## Product / Process Change Notification (PCN)

**PCN #:** PCN\_IndHCC\_20210122

**Affected Series:** WE-HCC 744334xxxx

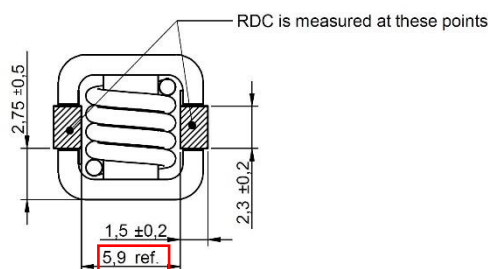
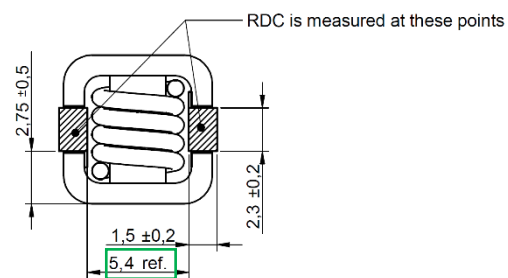
Because of a datasheet mismatch, Würth Elektronik will correct the reference dimension between the clips. There will be no change in form, fit, function, quality or reliability of the product.

The dimension will be corrected from 5,9mm to 5,4mm.
